**New High School in Wee Waa (SSD-21854025)
Request for additional information**

Attachment A – Key issues

Figure 3 Flood Mitigation Works Under Separate Planning Pathway: On-Site and Surrounding Works

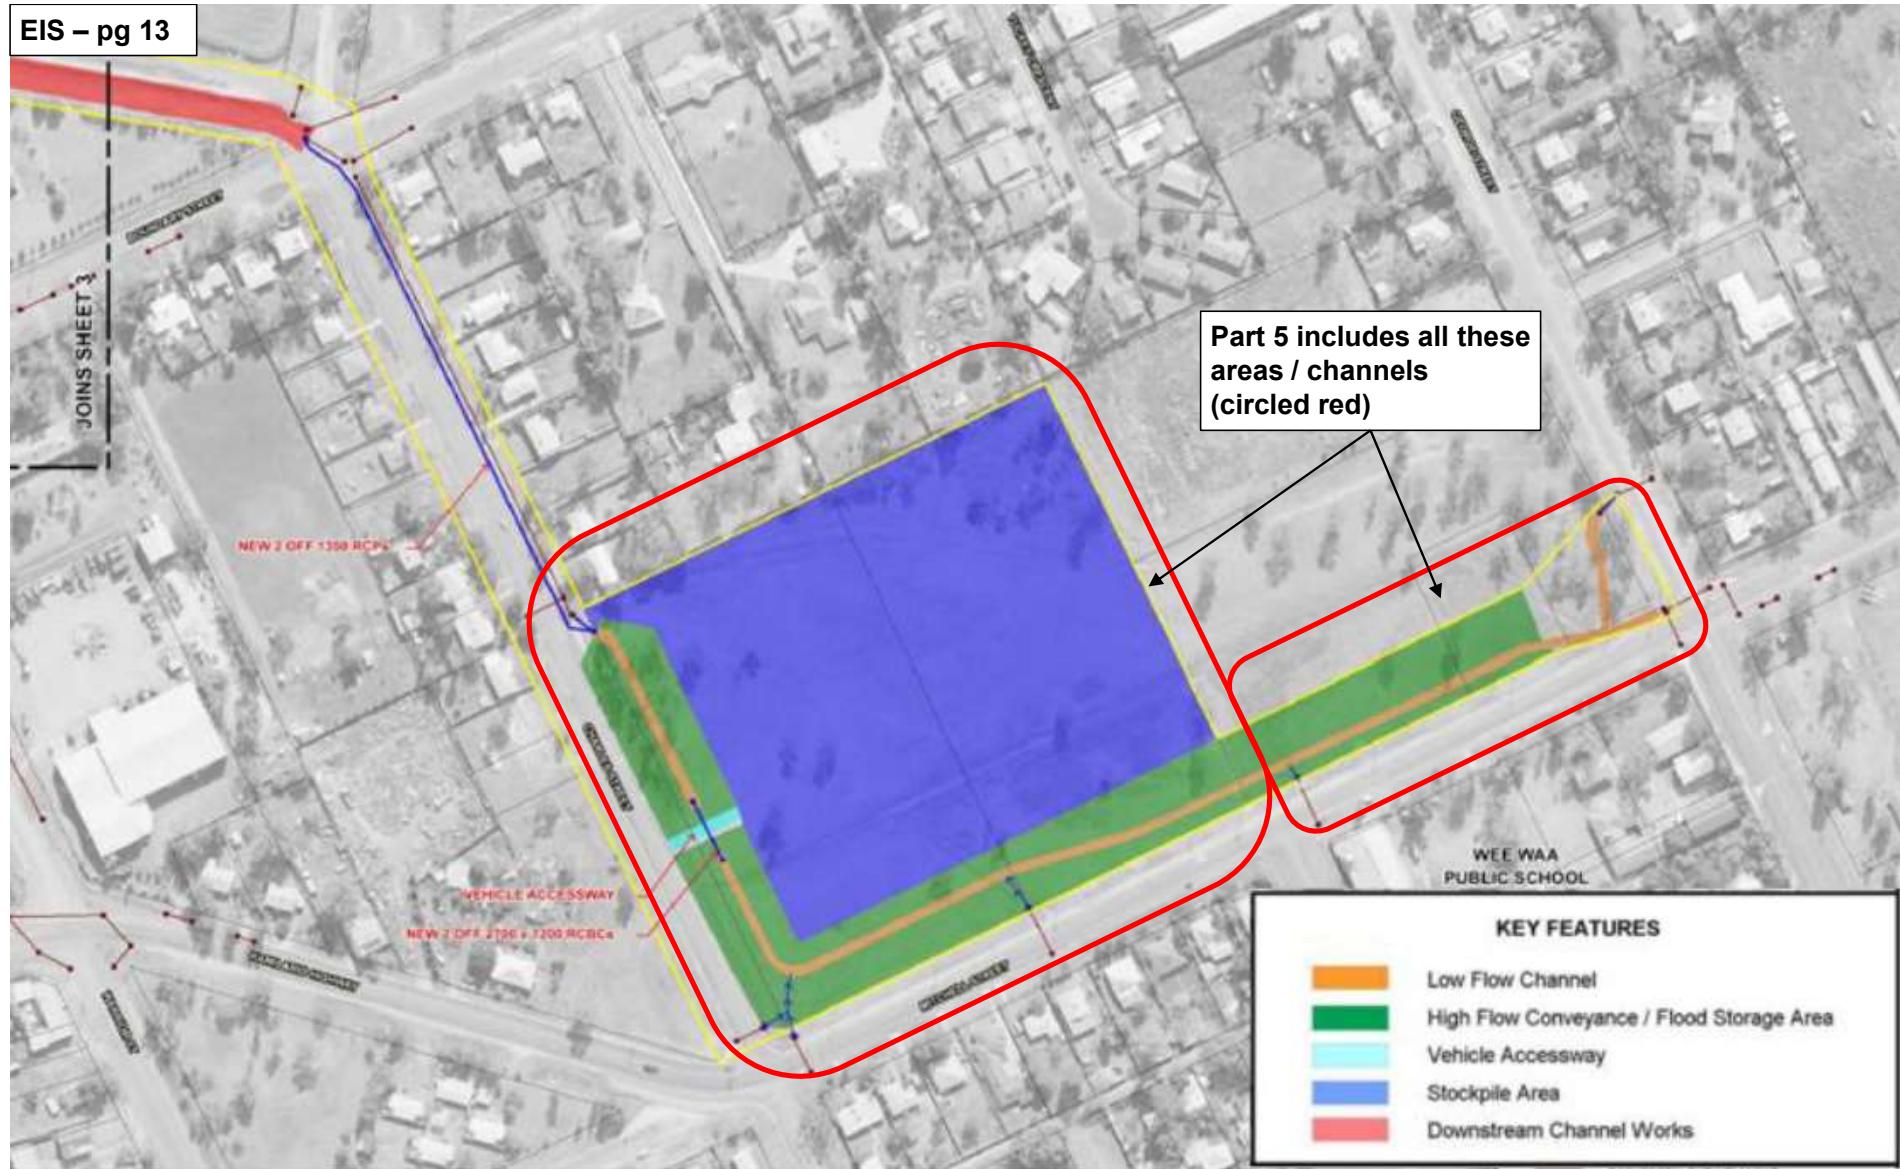
- As detailed in the Environmental Impact Statement (EIS), separate works including flood mitigation works, upgrades to the electricity distribution network and upgrades to the existing school agricultural plot are proposed on the site. These works ('Part 5 works') are proposed to be delivered via Part 5 of the *Environmental Planning and Assessment 1979* (EP&A Act). Please provide information addressing how the Part 5 works are consistent with section 4.38(4) of the EP&A Act.
- The EIS and the civil, landscape and architectural drawings all appear to show different boundaries and inclusions/exclusions for works that form part of the proposed separate Part 5 works (see Appendix 1 attached). All documentation and drawings must be updated for consistency and confirmation be provided of what components are undertaken in accordance under Part 5 / not part of this application.

Architectural drawings

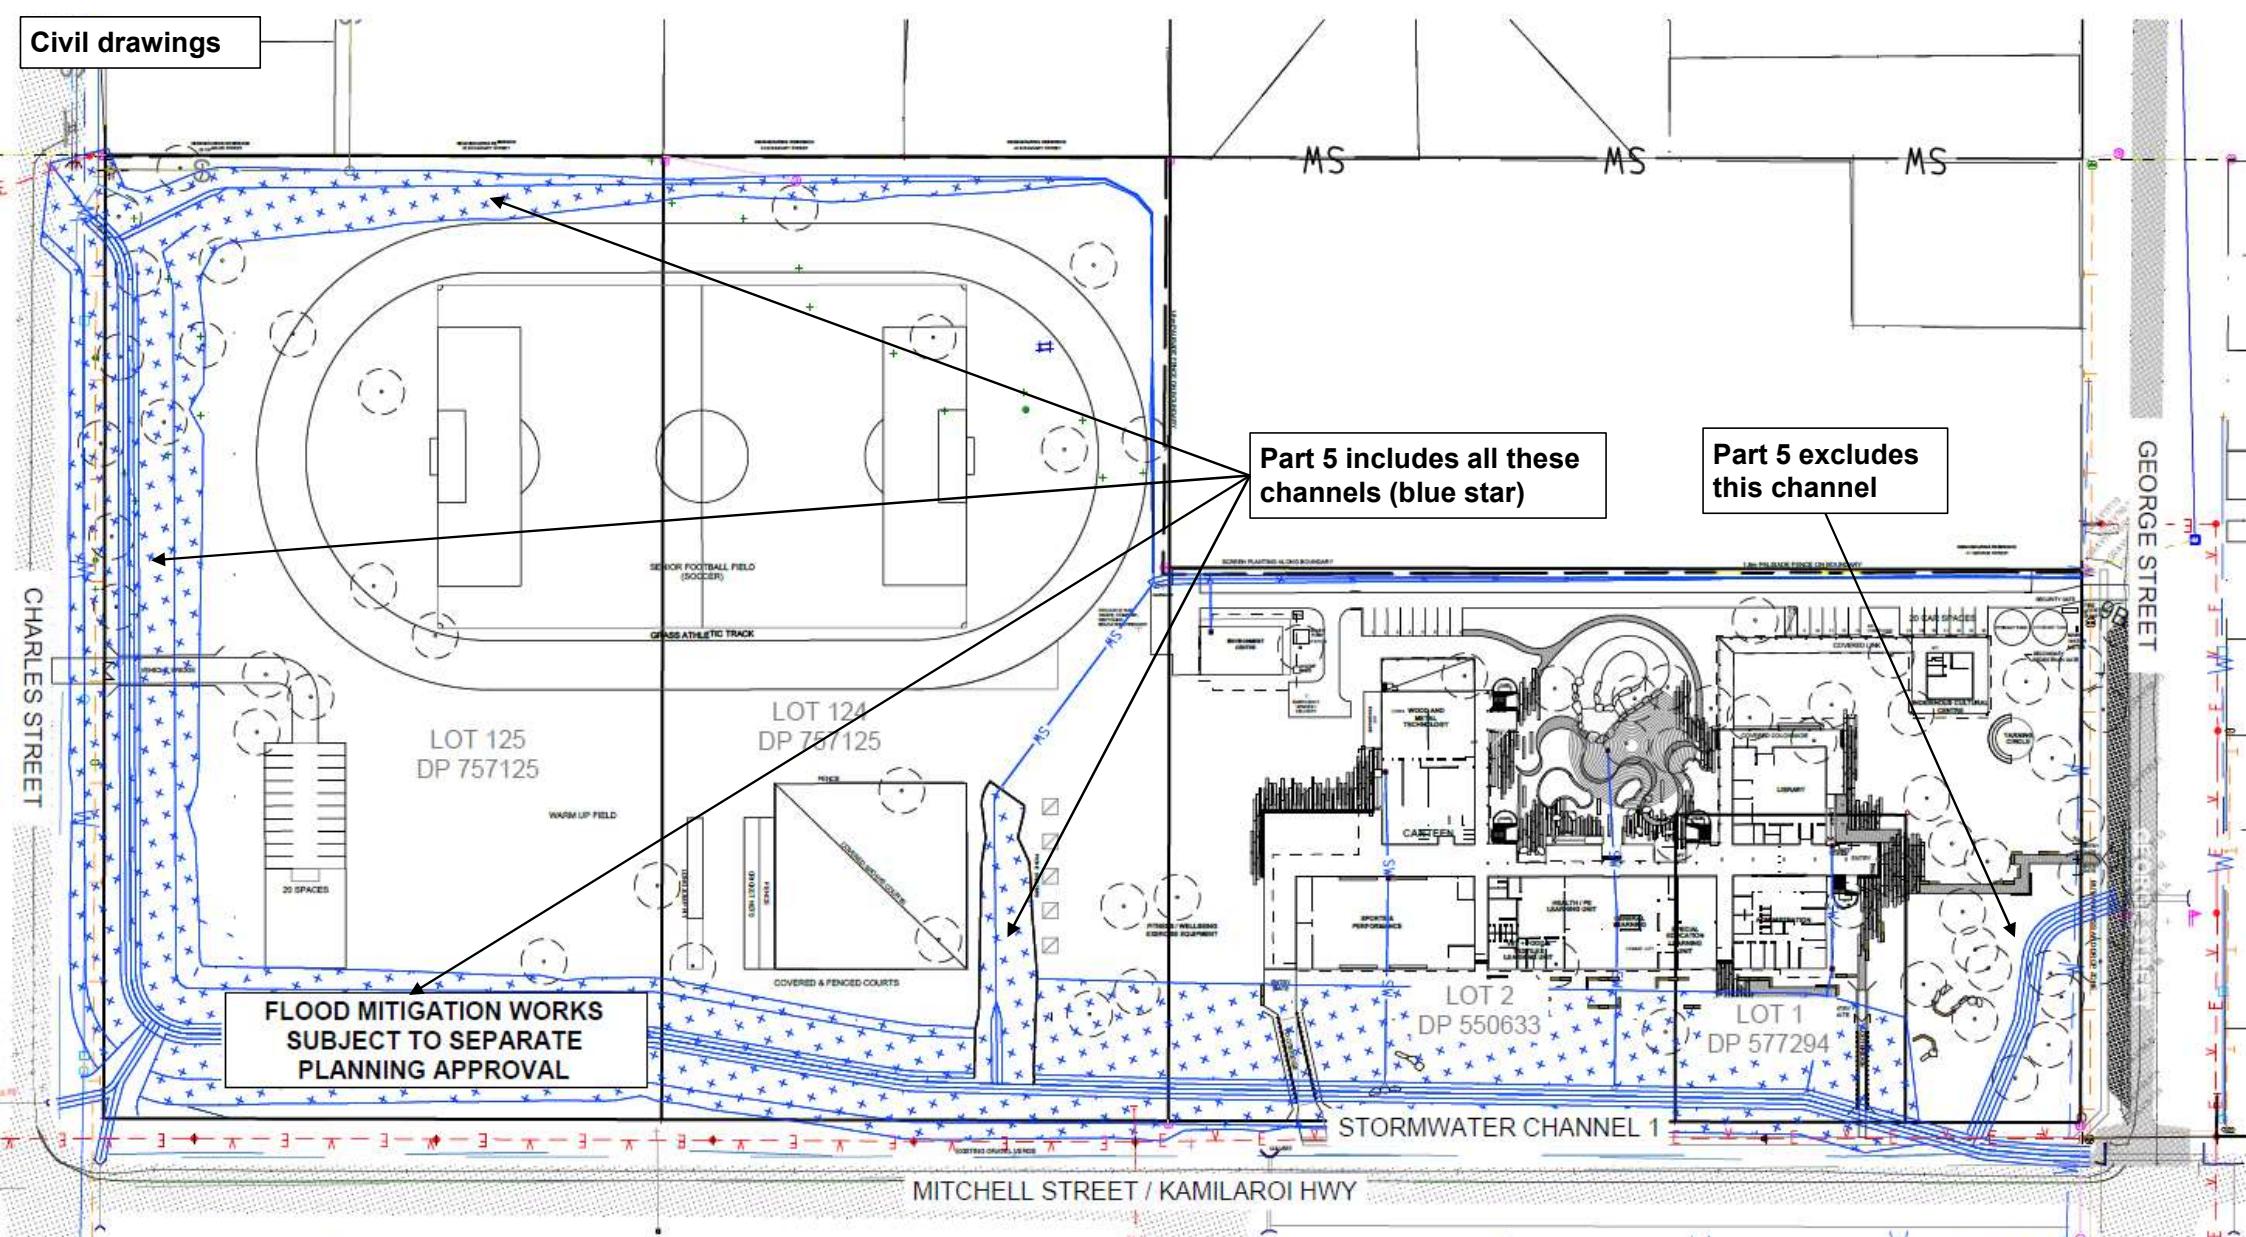
- the architectural drawings indicate a '2.4m Colorbond fence' along the northern boundary, '2.1m palisade fence' elsewhere, whereas the landscape drawings indicate a '2.1m fence' of unspecified material.

OVERALL LANDSCAPE PLAN

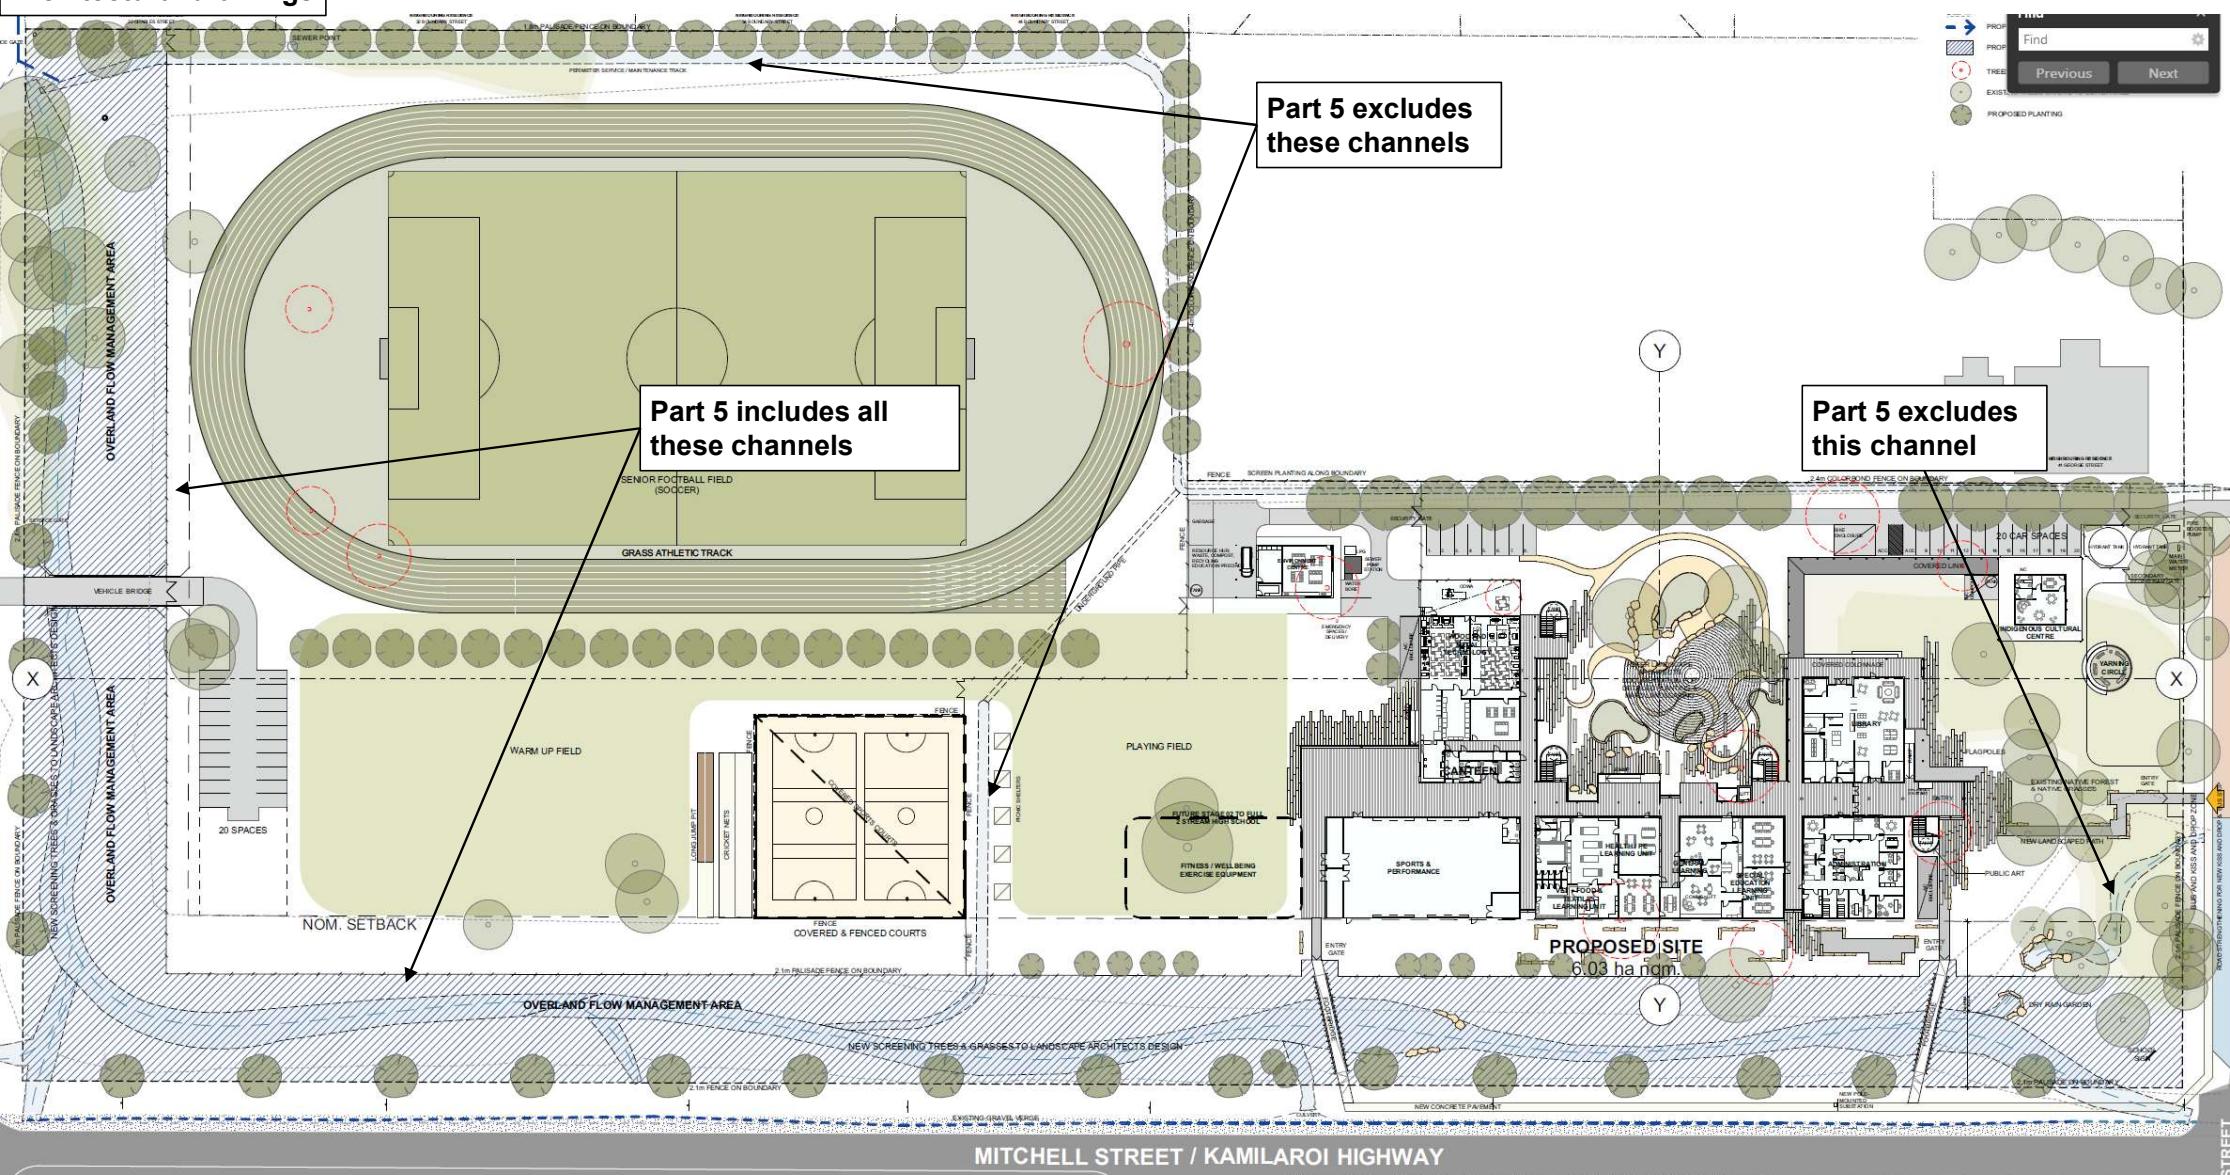
- Justify the inclusion of a high proportion of non-native tree species. In particular, consider replacing exotic species Japanese Zelkova and Chinese Elm with native alternatives that would contribute to biodiversity.

- Consider amendments to further retain trees of 'High' retention value, including:
 - consider retaining Tree 28, noting it is not located within or affected by the proposed building footprint.

- consider relocating the Agricultural building further westward to retain Tree 54.
 - consider the potential for the retention of Tree 26 by curving the access driveway around the tree.

- Update the landscaping drawing planting schedule to confirm the number of proposed trees and shrubs to be planted.
- Clarify what boundary fencing is proposed, noting:
